REVISED RESPONSE TO REQUEST FOR ADDITIONAL INFORMATION

APR1400 Design Certification

Docket No. 52-046

RAI No.: 249-8323
SRP Section: 03.08.01 –Concrete Containment
Application Section: 03.08.01
Date of RAI Issue: 10/14/2015

Table 3.8A-5

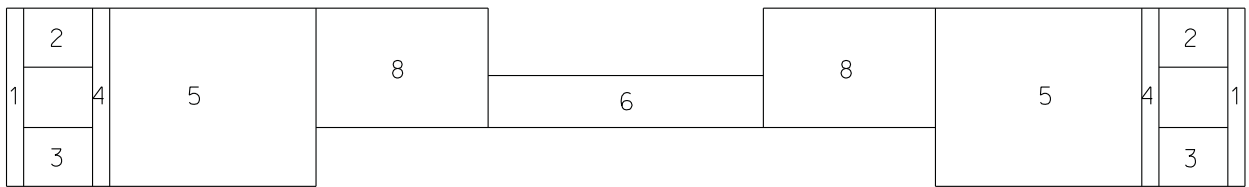
- d. Subsection 3.8.6, “Combined License Information,” COL item COL 3.8(10), “COL 3.8.(10)” should read “COL 3.8(10)”
- e. Table 3.8.A-5, “Critical Sections of RCB Basemat,” should be associated with Figure 3.8A-15, “Design Sections for Basemat Reinforcement.” Subsection 3.8A.1.4.2.3, “Analysis and Design Procedures,” provides the connection. However, in Figure (b) vertical area, between Sections 5 and 6 was not identified.

- e. DCD Tier 2, Table 3.8.A-5, "Critical Sections of RCB Basemat," will be revised to indicate the excluded design sections, indicated in the "Location" column, include Section-07 instead of Section-08. DCD Tier 2, Figure 3.8A-15, "Design Sections for Basemat Reinforcement," will be revised to identify the vertical area between Sections 5 and 6 as Section 8, as shown in Attachment 5 to this response.
